# Appendix C-4

## UXR Responses to Comments – AQ/HRA/GHG

**DATE:** May 16, 2024  
**TO:** Nicole N. Cobleigh, Dudek  
**FROM:** Urban Crossroads  
**JOB NO:** 14064-01 RTC

## WEST CAMPUS UPPER PLATEAU RESPONSE TO COMMENTS

Figure 2 – Regional map of existing, approved, and planned warehouse projects within Riverside County.

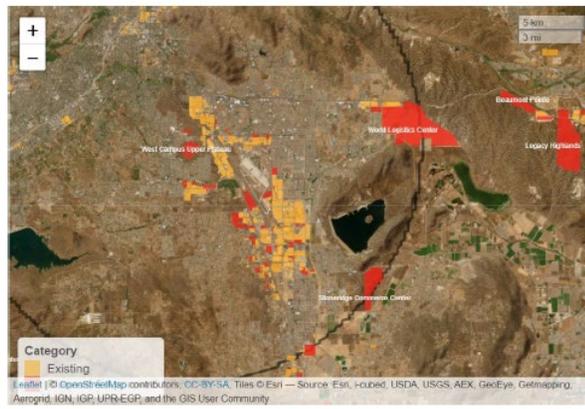
*In the regional analysis of cumulative air quality impacts, the scope of the analysis is completely inadequate. As mentioned in the cumulative impacts letter, the Air Quality section’s regional scope is the South Coast Air Basin. Even if we limit the scope to merely a 10-mile buffer around the project, the intense scale of warehouse development along the 215/60 corridor is obvious as shown in Figure 2. The existing footprint<sup>12</sup> of warehouses is over 280 million square feet. The cumulative additional footprint of approved and planned warehouses in the region is another 207 million square feet, nearly doubling the existing footprint and cumulatively approaching a half a billion square feet devoted to warehouses within 10 miles of this project. The March JPA has 5 million square feet approved and under construction. Moreno Valley has the enormous World Logistics Center contributing over 100 million square feet of warehouse footprint. The County of Riverside has many projects in Mead Valley and the large Stoneridge Commerce Center (~20 million square feet footprint) near Nuevo. The Project’s cumulative impact project list omits 90% of this area and projects, deliberately underestimating the regional scale of the past, present, and proposed future projects. Given the regional character of air quality problems in the SCAQMD area, it is important to identify the regional patterns in development that are characterizing the local land-use authority decisions cumulatively.*

*1) Demonstrate that the Operational Phase Air Quality thresholds of significance are not completely understated when including regionally representative operational emissions for the 100 million square feet of warehouses already operational and cumulatively impacting air quality. Please account properly for the additional planned/approved warehouses regionally that will add another 50 million square feet of warehouses as shown in Figure 2. This is important for the regional nonattainment of NO<sub>2</sub>, ozone, and PM<sub>2.5</sub> and the estimated cumulative regional impact.*

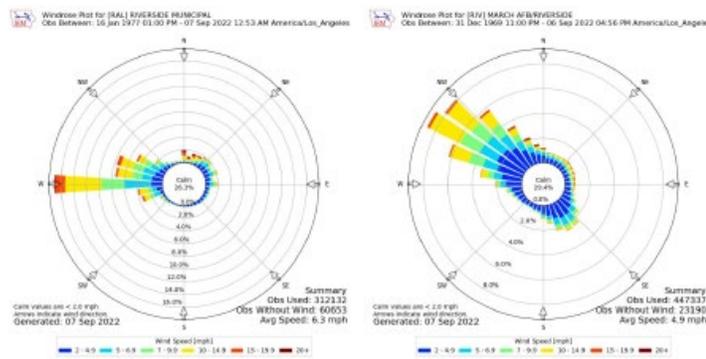
4.2-18 – KRAL is almost 8 miles from the project site and nearly 900 feet lower in elevation – March ARB has meteorological data and is less than 1 mile from the project site. As can be seen from a basic check of the runway orientations for the two airports, KRAL is completely inappropriate for use in meteorological dispersion modeling of this project. Winds at Riverside Municipal are channeled along the Santa Ana river valley east-west – its elevation is 820’ ASL. March Air Reserve Base is at 1535’ ASL and winds are predominantly north-northwest to south-southeast. March Air Reserve Base winds are significantly slower and lower than at RAL, which increases stagnancy and is less effective at dispersion. There is no scientifically valid reason to choose a less representative airport for winds for this project, especially since it will indicate lower pollution impact due to the higher winds and incorrect direction of winds.

Windroses from Riverside Municipal airport and March AFB – both are fully publicly available as ASOS data here: [https://mesonet.agron.iastate.edu/sites/windrose.phtml?station=RIV&network=CA\\_ASOS](https://mesonet.agron.iastate.edu/sites/windrose.phtml?station=RIV&network=CA_ASOS)

If data from the SCAQMD must be used, the Perris data would be more representative of the local wind field than Riverside Municipal Airport.

The comment states that the use of meteorological data from Riverside is not appropriate and recommends the use of data from March ARB or Perris. Meteorological data from the SCAQMD’s Riverside monitoring station was utilized as this represents the nearest monitoring station to the Project site. As shown below, the Riverside monitoring station is located approximately 7.65 miles from the Project site, while the Perris Valley monitoring station is located approximately 8.30 miles from the Project site. SCAQMD does not provide meteorological data for March ARB. Data from SCAQMD’s Perris monitoring site was not used as this location is located further from the Project site. Additionally, the Riverside monitoring station is located in the same source receptor area as the Project (SRA 23) and is closer to the Project, while the Perris monitoring station is located in a different source receptor area (SRA 24) and is farther away. SCAQMD’s jurisdiction is divided into several SRAs which reflect areas with similar topography, meteorological conditions, and air quality.

**Figure 1-** Map of project area, surrounded by a 1-mile buffer. Warehouse colors indicate the jurisdiction responsible for land-use authority, while the fill indicates an existing (white) or planned/approved (gray) warehouse project.

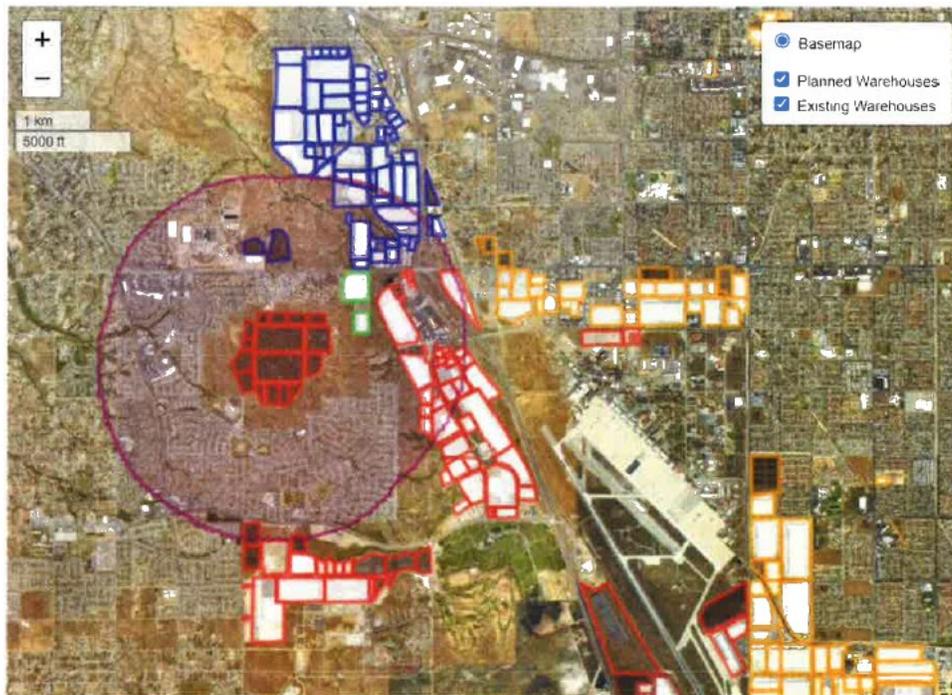
*I find the geographic scope of analysis listed in Table 4-1 to be inconsistent with the definitions of geographic vicinity listed in the draft EIR.*

*On page 4-3, it states, 'Unless otherwise indicated in the analysis in Chapter 4 of this Draft EIR, the geographic scope used in the cumulative analysis includes the March JPA planning area.' It is obviously clear that at the March JPA planning area is not completely included in the Table 4-2 cumulative impacts project list.*

**Figure 2** - 10-mile regional buffer region with warehouses (existing and planned/approved) overlaid. Existing warehouses have a white fill, while approved/planned warehouse areas are filled in gray.

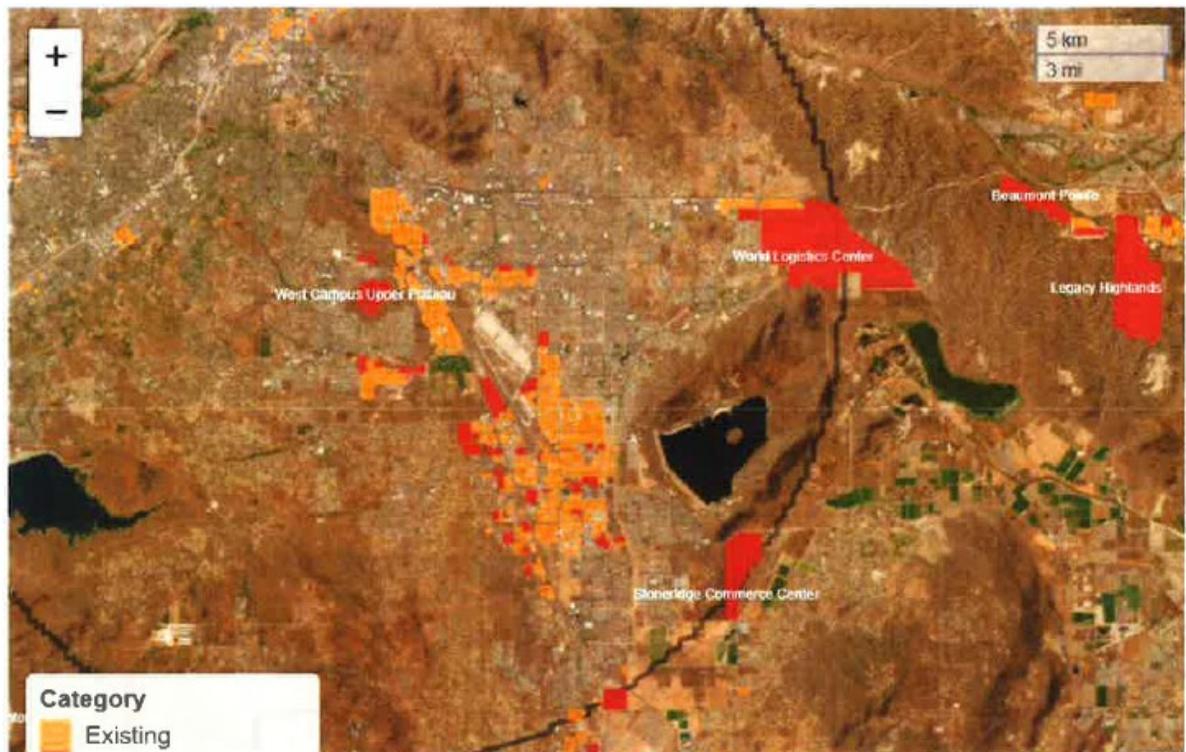
*Figure 2 helpfully identifies a 10mile buffer region around the project boundary, although I only include Riverside County warehouses to focus on the 215/60 corridor impacts as the primary transportation and land-use bottle-neck is within the Riverside county portion.*

The existing regional warehouse footprint of warehouses is approximately 280 million square feet. The planned and approved warehouse footprint includes another 200 million plus square feet of land, nearly doubling the existing footprint.

**Figure 3** - Existing and planned/approved warehouse development in a 15-mile ring (black circle) around the West Campus Project.

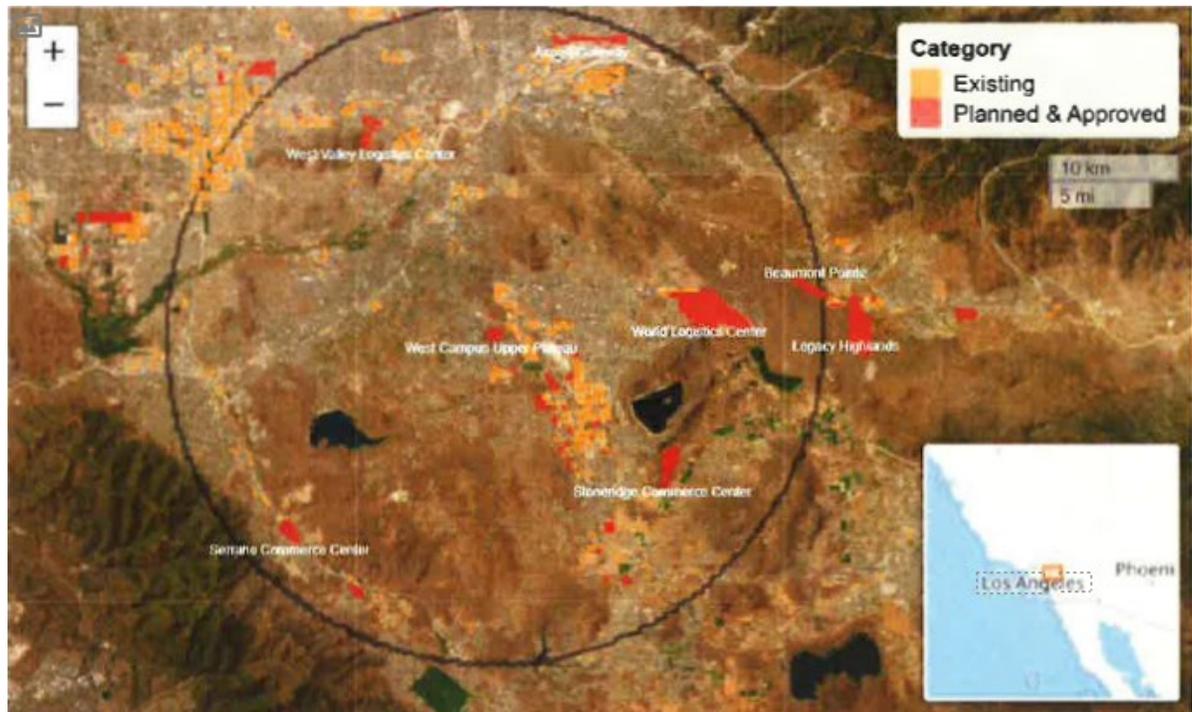
I leave you with one last map showing the 15-mile regional buffer of warehouses within our region. It includes some of the other mega-projects just at or beyond the regional boundary defined in the Transportation analysis section. Figure 3 shows the whole Inland Empire, a 15-mile buffer boundary around the project, and a few labeled mega-warehouse complexes that have been approved or are in planning stages ranging from NOP to draft EIR. Key complexes not mentioned yet include the Serrano Commerce Center, West Valley Logistics Center, Speedway Commerce Center, Airport Gateway, Bloomington Business Park, South Ontario Logistics Center, Merrill Commerce Center, and the Renaissance Ranch Commerce Center, and the South Perris Industrial Center.

To put this in proper perspective, it needs to be explicitly addressed in the EIR and these project lists are 100% consistent with the geographic scope listed in Section 4.0. Please add these projects and do a truly comprehensive analysis of the regional impacts of warehouse growth.

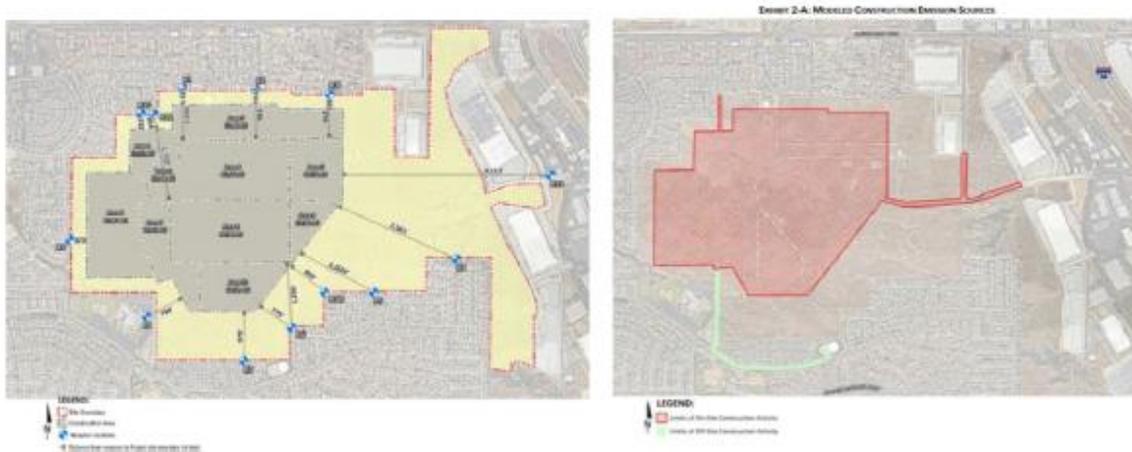
Figure 4.2-1 shows the 'Construction Areas' modeled in the HRA and the selected Sensitive Receptors alongside the project boundaries. Exhibit 2-A in Revised Technical Appendix C-2 shows a different set of modeled construction activity boundaries. Both are shown below for completeness. I can't tell from the description in the text (REIR or appendix) how emissions are actually allocated within the project area, but the text in the REIR states that on p.4.2-24 'Because this construction would be limited in scope, short-term, and intermittent in nature, and cease upon completion, and resulting health impacts to nearby sensitive receptors would be negligible related to construction of the proposed Project and would not materially affect the determination of the maximum exposed individual receptors for the purposes of this health risk assessment.' There are no quantified values for the duration, extent, or intermittent construction phase emissions nor any actual modeling to assess exposure for homes within 10 feet of construction activity. It is not reasonable to assert those emissions and exposures are negligible a priori. This is attempting to piecemeal the project; omitting portions of the project violates the principle of considering the 'entirety of an action'.

Secondly, the distances shown in Figure 4.2-1 are incorrect, because they are taken from the Specific Plan construction zone, rather than the actual construction areas, as shown in Exhibit 2-A. A few key examples are identified.

The comment includes two figures: Figure 4.2-1 of the EIR, which identifies sensitive receptor locations in relation to the Specific Plan Area and Exhibit 2-A detailing the modeled construction emissions sources. The construction HRA assumed that construction-source emissions would occur over the Project site (denoted by the area in red in Exhibit 2-A) over the entirety of the 4.35 years of construction. Exhibit 2-A has been updated to include the distances from the sensitive receptors to the modeled construction emissions sources. Figure 4.2-1 of the EIR (also Exhibit 2-D of the Project HRA) has been updated to clarify the distances are provided for operational emissions. Although not modeled separately, the offsite construction emissions are included in the overall Project DPM emissions as stated in the Project HRA.

As shown on the revised Exhibit 2-A, the closest sensitive receptor (Receptor 11) is 32 feet from construction activities, specifically the northern Barton Street extension and the Mixed Use parcels of the Specific Plan Area. This distance is conservative, as although the comment states that construction activities would occur less than 5 feet of Receptor R11, Receptor R11 was placed at the edge of the backyard facing construction activities, and the analysis assumes that a

As shown on the revised Exhibit 2-A, construction sources were placed along the Barton southern extension for a distance of approximately 1,250 feet south of the Campus Development, which places these sources within 80 feet to the preschool at Receptor R8. At the maximally exposed individual school child (MEISC), the maximum incremental cancer risk impact attributable to the Project construction activity is 0.05 in one million, which is less than the significance threshold of 10 in one million. The analysis conservatively assumed that these sources would be active the entire 4.35 years of Project construction, even though actual construction activities in this area would be significantly shorter.
